CONNECTORS AND INTERLOCK LOGIC

PELICAN - SWAN CONTROL INTERFACE

Bowe Bell + Howell Scanners L.L.C		
Title Connectors		
Size B	Document Number S008103	Rev A
Date: Wednesday, February 27, 2008	Sheet 3	of 7

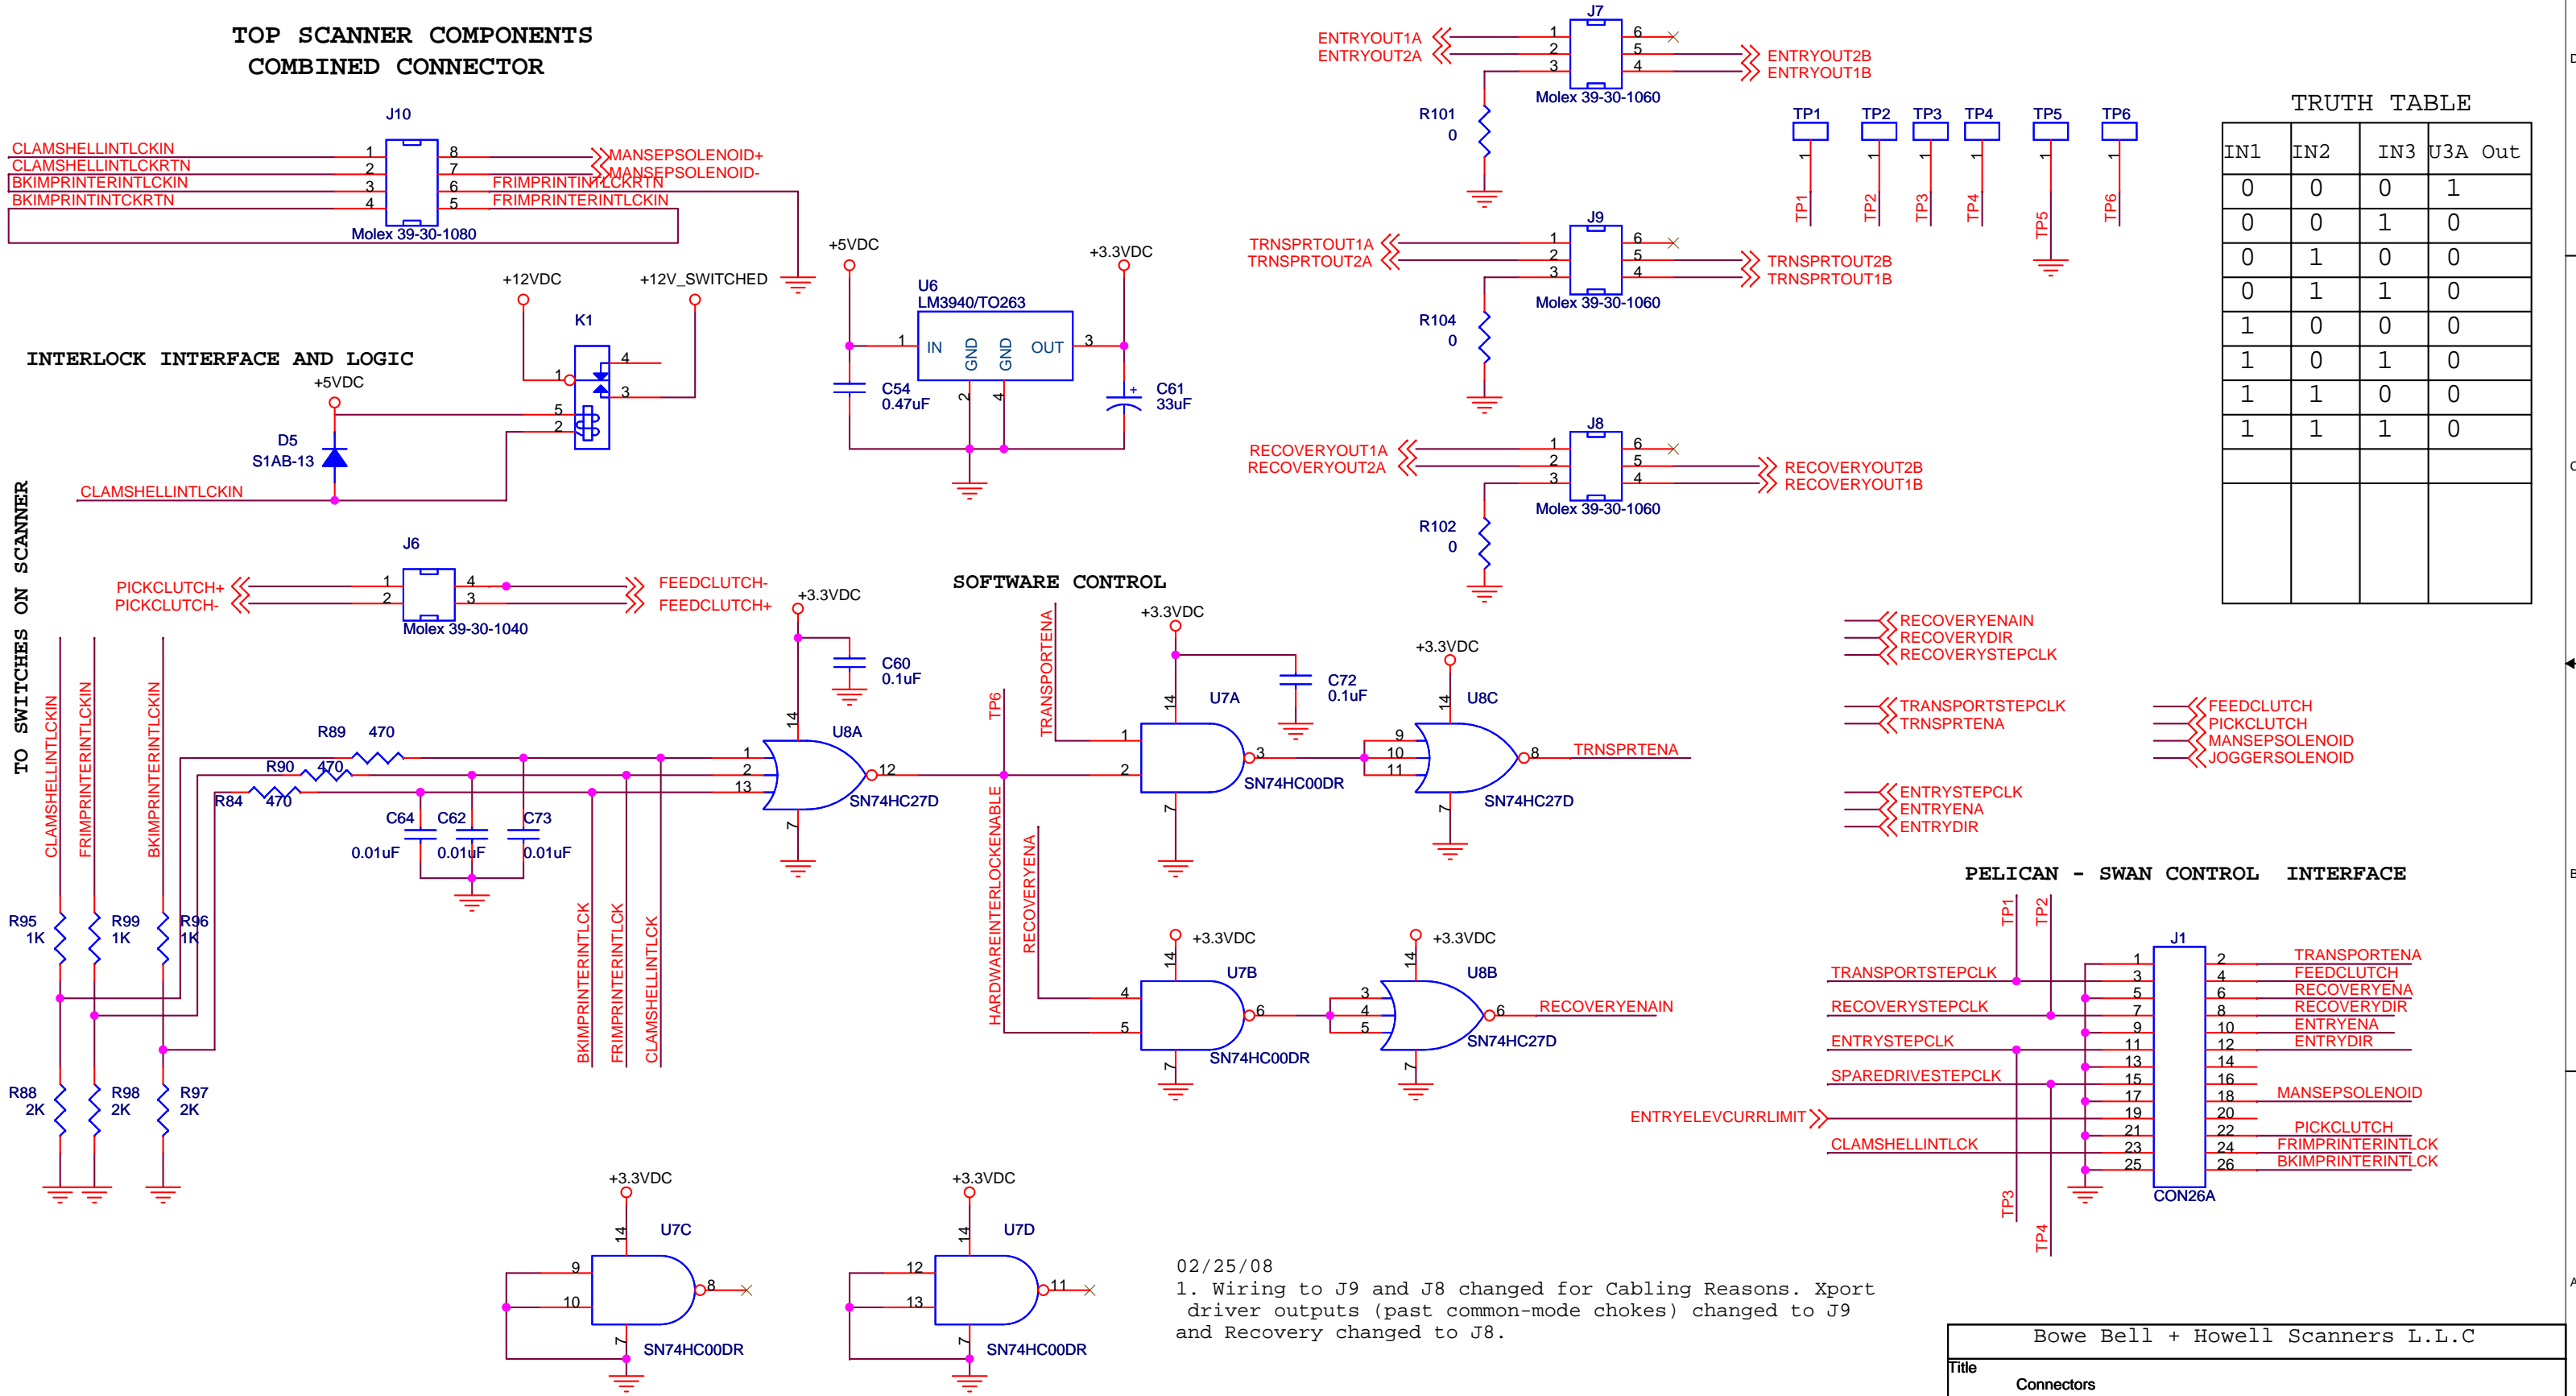
02/25/08
1. Wiring to J9 and J8 changed for Cabling Reasons. Xport driver outputs (past common-mode chokes) changed to J9 and Recovery changed to J8.
